UNITED STATES PATENT AND TRADEMARK OFFICE

APPLICATION NO.	FILING DATE	FIRST NAMED INVENTOR	ATTORNEY DOCKET NO.	CONFIRMATION NO.
10/600,668	06/20/2003	John M. Lynch	P16911	5684
28062	7590	03/19/2004	EXAMINER	
BUCKLEY, MASCHOFF, TALWALKAR LLC 5 ELM STREET NEW CANAAN, CT 06840			NGUYEN, TRUC T	
			ART UNIT	PAPER NUMBER
			2833

Office Action Summary

DETAILED ACTION

EXAMINER'S ATTACHMENT
FOR 10/ 600, 668

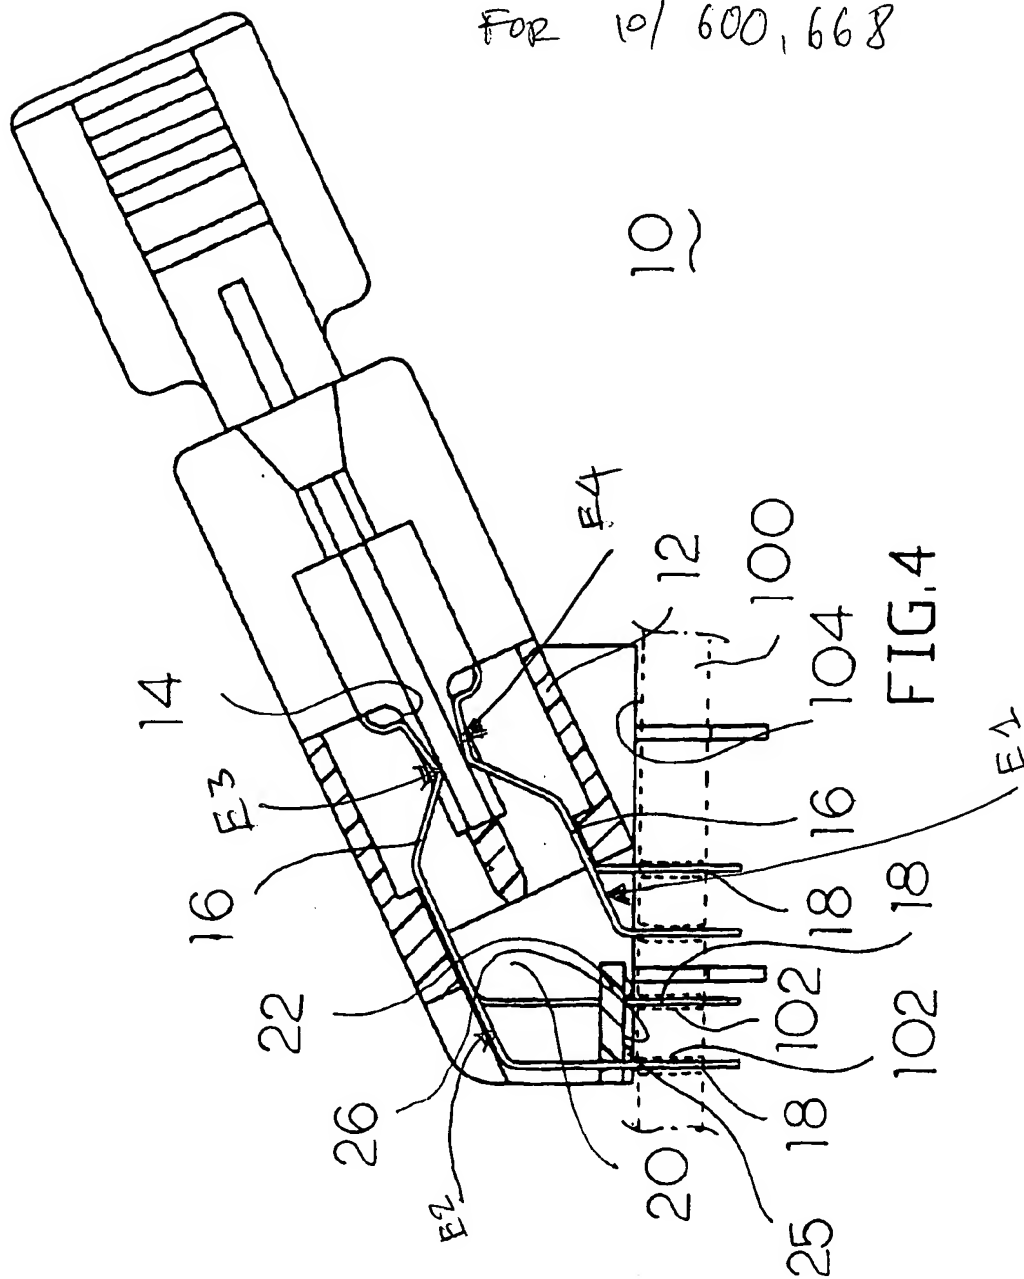
a first contact (E1, see Examiner's attachment) having a first length, a first module connection (E4, see Examiner's attachment) protrude into opening (14), a first signal line (18);

a second contact (E1) substantially the same with the first contact and dispose adjacent and on the same side with respect to the connector housing;

a third contact (E2, see Examiner's attachment) having a second length, a third module connection (E3, see Examiner's attachment) protrude into opening (14), a third signal line (18);

a fourth contact (E2) substantially the same with the third contact and dispose adjacent and on the same side with respect to the connector housing;

the first length is not equal to the second length;
